South Texas Project Electric Generating Station P.O. Box 289 Wadsworth, Texas 77483

October 21, 2003
NOC-AE-03001624
STI: 31665347
FILE NO: Z18
ER 20030047
10CFR50.4(b)(5)
10CFR50 App E

STP NUCLEAR OPERATING COMPANY
Units 1 and 2
Docket Nos. STN 50-498; STN 50-499
Changes to Emergency Plan Procedures

In accordance with 10CFR50.4(b)(5) and 10CFR50, Appendix E, Section V, the STP Nuclear Operating Company hereby submits the attached Emergency Plan Implementing Procedure revisions.

Protective Response Zones Map

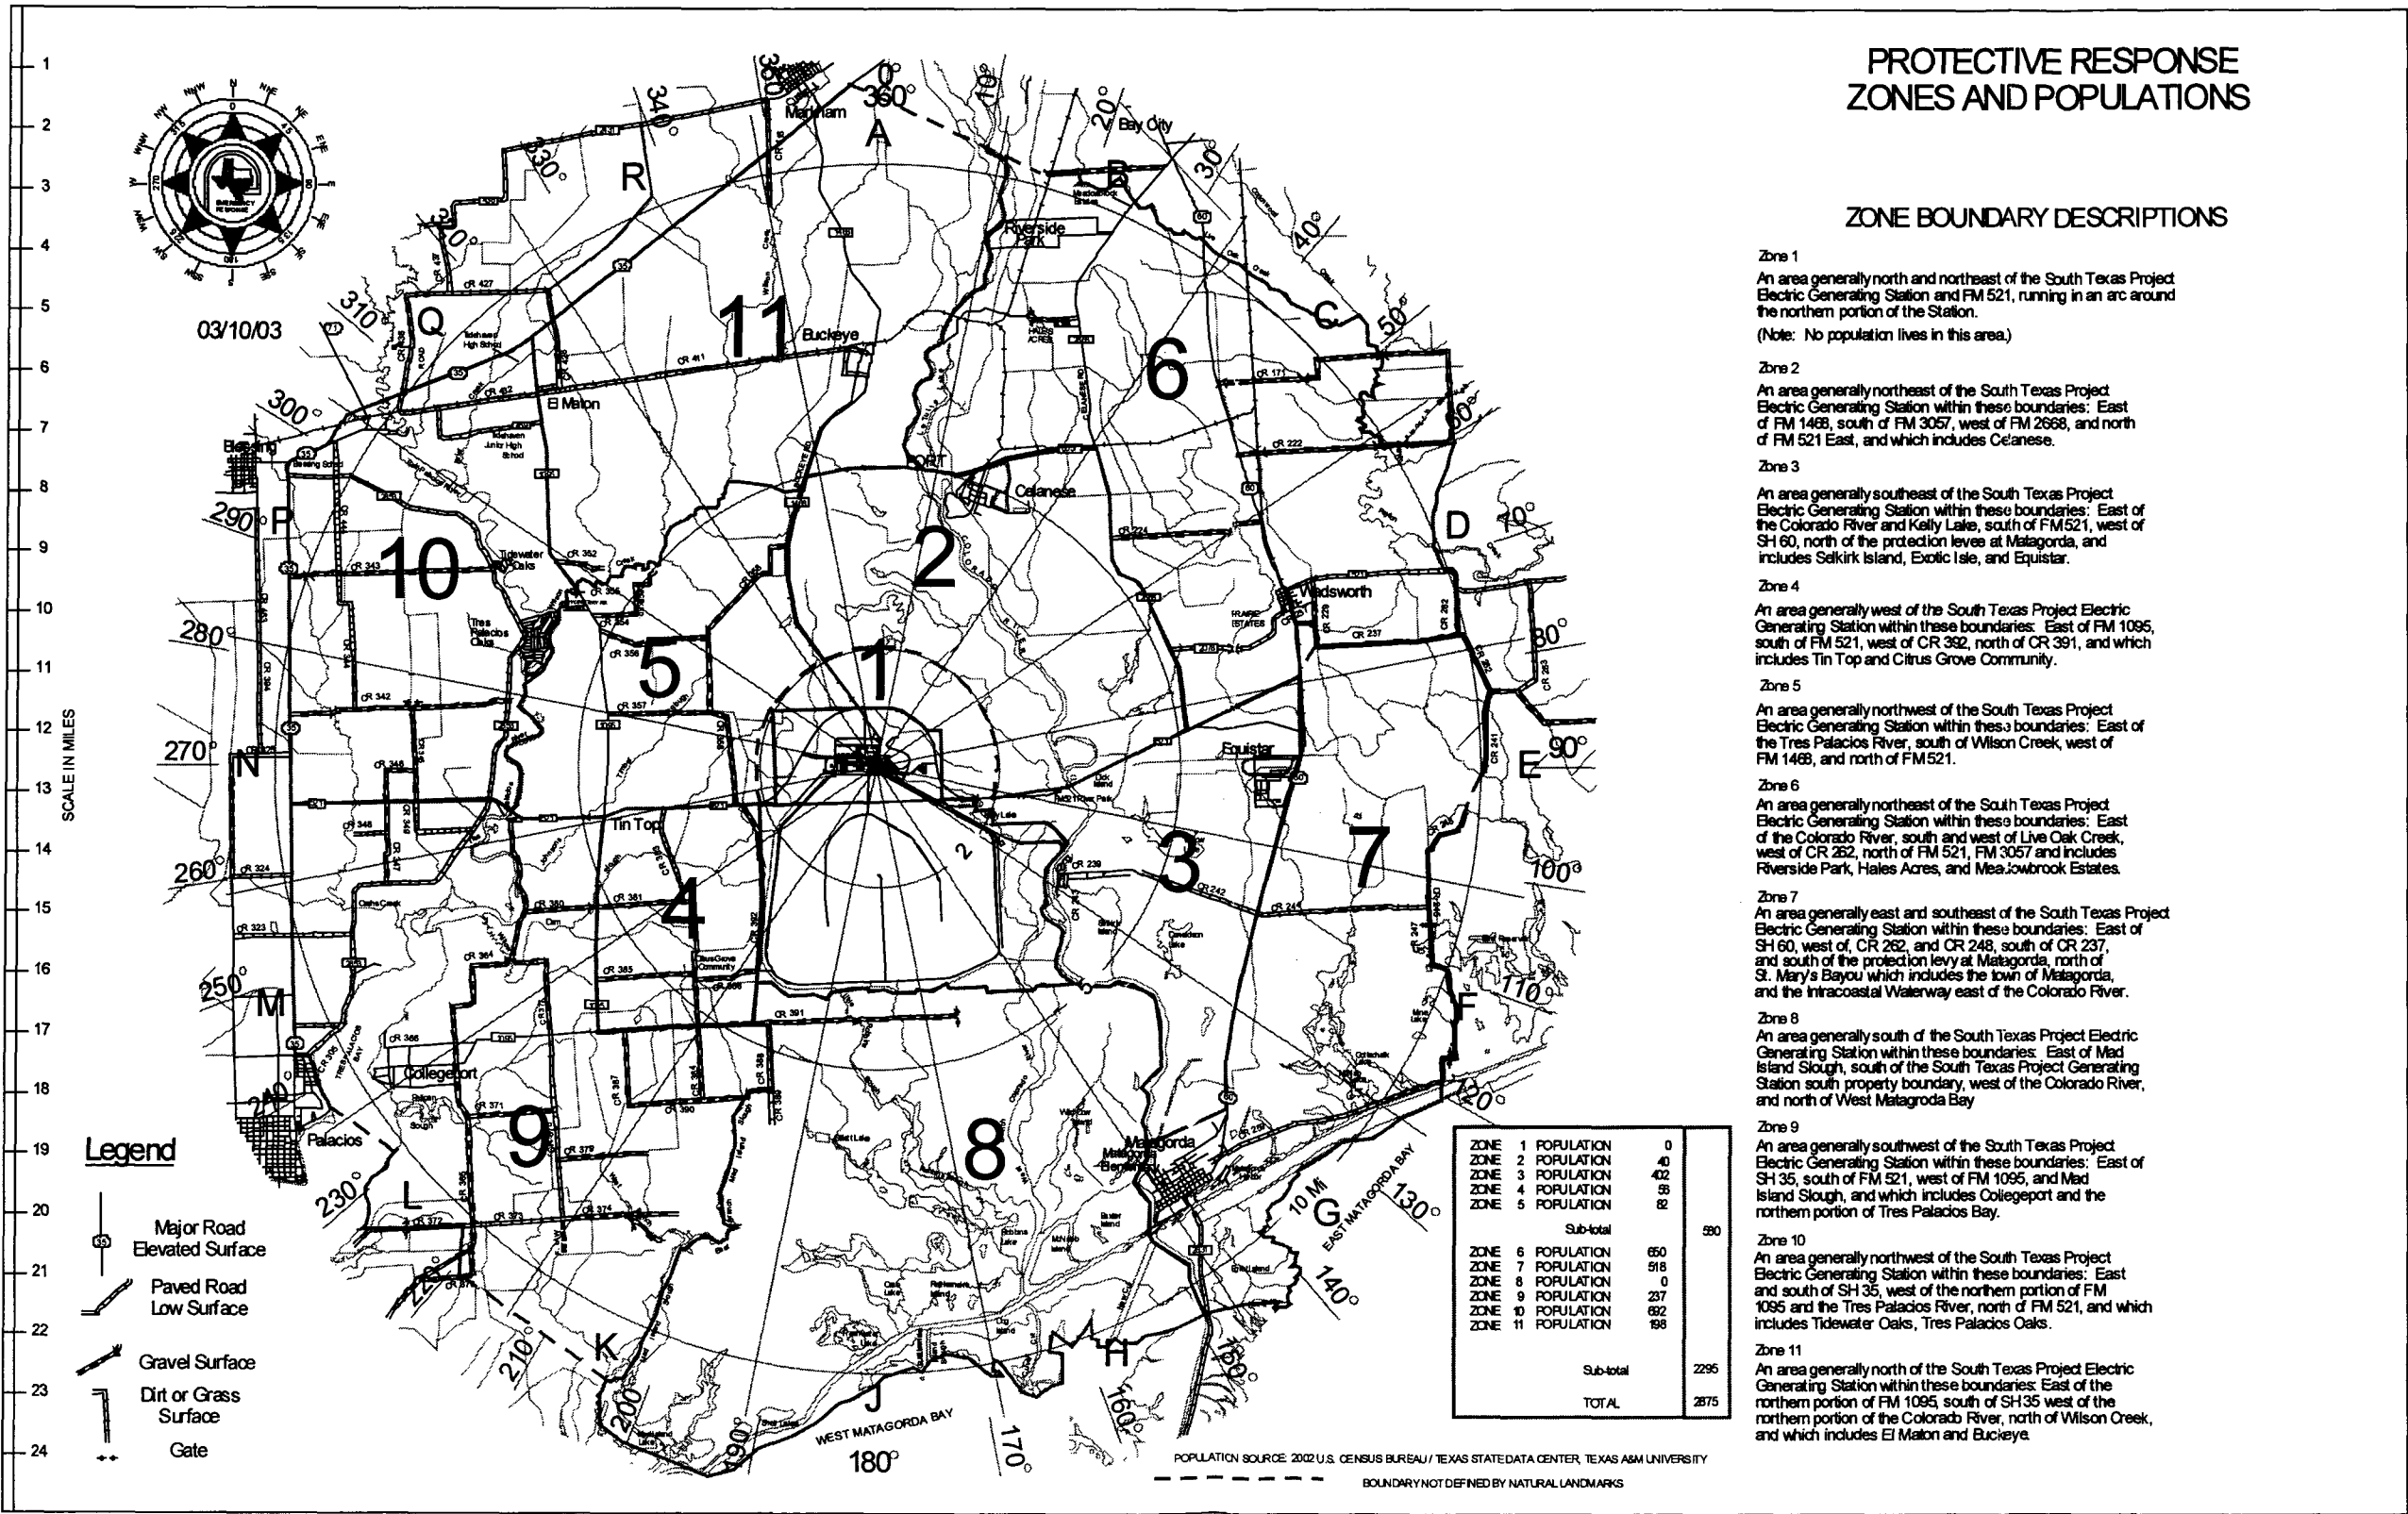
NO	CHANGE	REASON
1	Page 6, Added Zones to 5 Mile Radius	Clarification
2	Page 8, Added Hatch Monitor and instructions.	Clarification due to TSC-288.

0ERP01-ZV-SH01	Rev. 18	Page 6 of 34
Shift Supervisor			
Addendum 1	Protective Action Recommendation Flowchart		Page 1 of 1

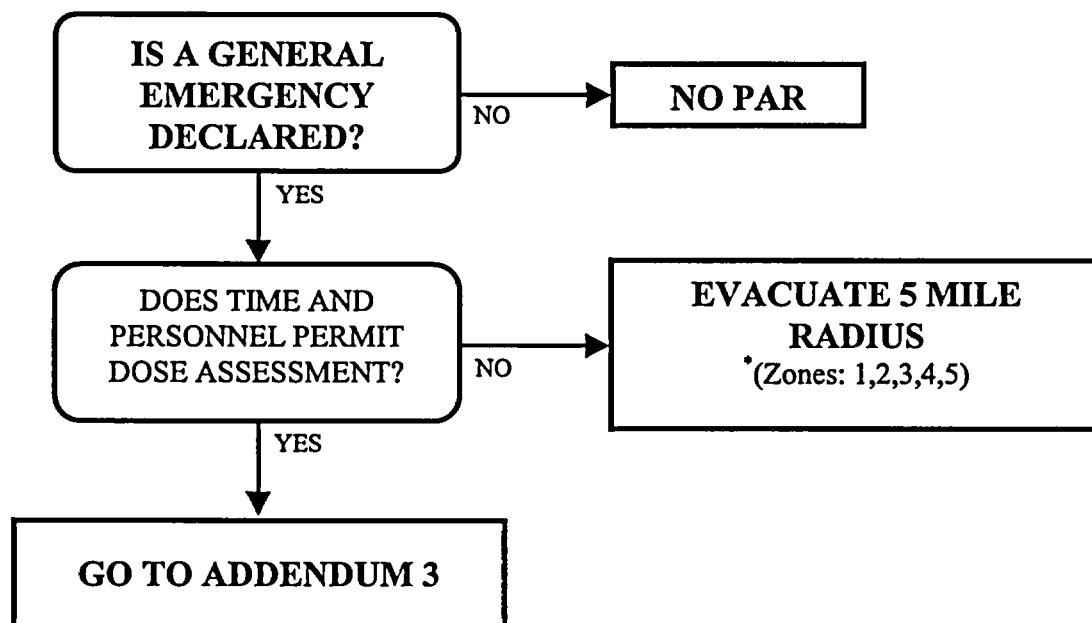
NO	CHANGE	REASON
1	Page 6, Added Zones to 5 Mile Radius	Clarification
2	Page 7, Added Hatch Monitor and instructions.	Clarification due to TSC-288.
